Change 1

Change 2

Figure 15. Recommended circuit to Guarantee Hiccup Mode Showing Typical Values

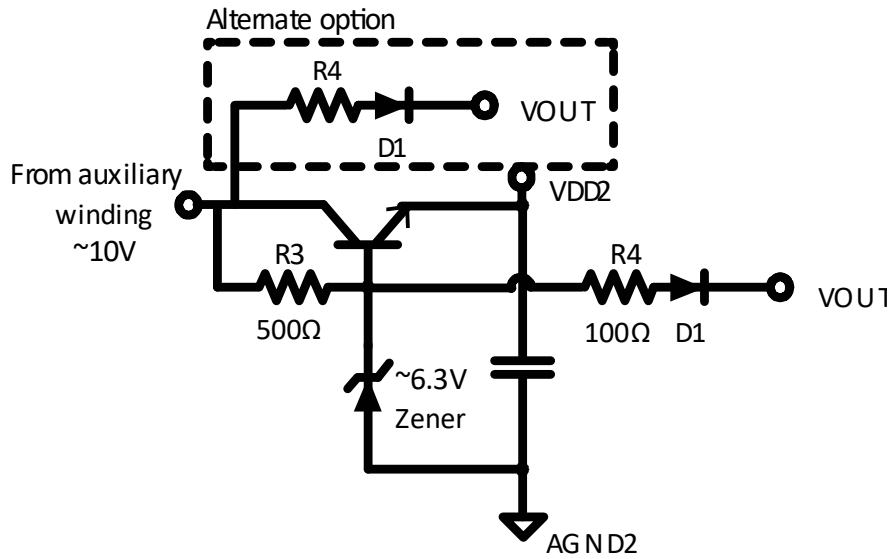
2. When VDD2 is powered through auxiliary winding or another configuration, when a short circuit occurs on the output terminals, the auxiliary winding is not shorted and maintains a positive voltage above the VDD2 UVLO threshold. To enter hiccup mode, the following circuit is recommended, as shown in Figure 15. The circuit operates as follows: when the output voltage goes low due to a short circuit, the D1 diode turns on, which pulls the base of the BJT { Bipolar Junction Transistor} low, shutting off VDD2. The system then enters hiccup mode, as described in the **Error! Reference source not found.** section.

R3 is sized to bias the Zener diode and R4 is sized such that $(V_{ZENER} − 1)/R4 > I_{ZENER}$, where V_{ZENER} is the voltage of the diode and I_{ZENER} is the biasing current of the diode. This sizing ensures that the impedance of the resistor is less than the impedance of the diode, which causes the voltage of the diode to drop, and allows VDD2 to enter UVLO.

If the output voltage is <5 V, the same procedure can be used to size the R4 resistor. If a discrete LDO is not used, a simple resistor and diode connector to the output voltage is sufficient. In this case, the R4 resistor is

sized to limit the current through the D1 diode when the output voltage is 0 V during a short circuit event. Because the bandwidth of the system is high, the ADP1074 is able to maintain voltage regulation at the proper voltage level, even if the auxiliary winding voltage is higher than the output voltage. The soft start and soft start from precharge conditions is met with the addition of this circuit due to the bandwidth of the overall system.
